IBM 8260 Multiprotocol Intelligent Switching Hub Ethernet 10-Port 10BASE-FB Module Release Note

IBM Corporation • IBM Part Number 29H4248 • August 25, 1995

This release note applies to the IBM 8260 Ethernet 10-port 10BASE-FB Module (Model Number E10PS-FB) at software Version 1.0 of the boot code and Version 1.05 of the operational code.

Figure 1. 10-Port Module and DIP Switch Location

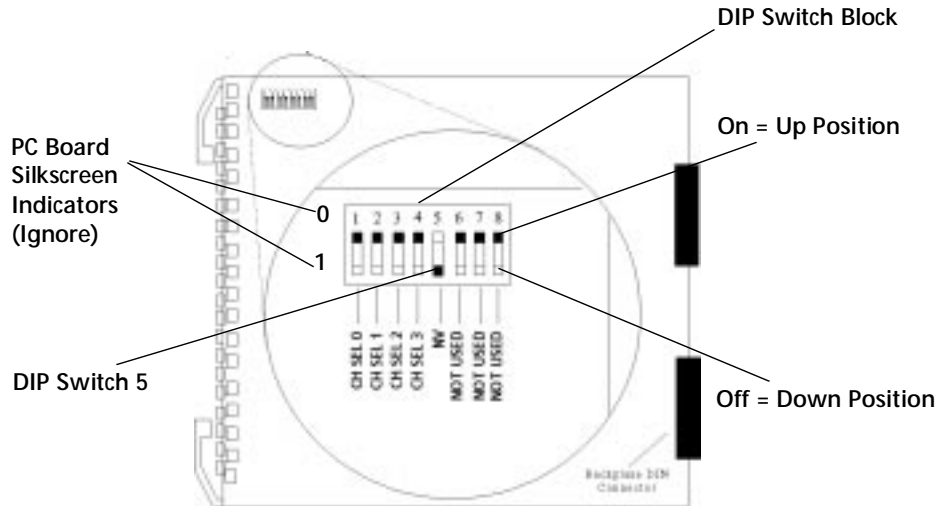
Figure 3-1 on page 3-6 of the *8260 Ethernet 10-Port 10BASE-FB Module User's Guide* displays an incorrect DIP switch illustration. Refer to the following figure and notes when setting DIP switches.

Note: **DIP Switch 5** must be set to the positions listed below when configuring network assignments using:

- NVRAM in OFF (down) position
- DIP switch in ON (Up) position

Note: Ignore the **0** and **1** PC board silkscreen position indicators on the left side of the DIP switch block. This is a hardware issue *only*.
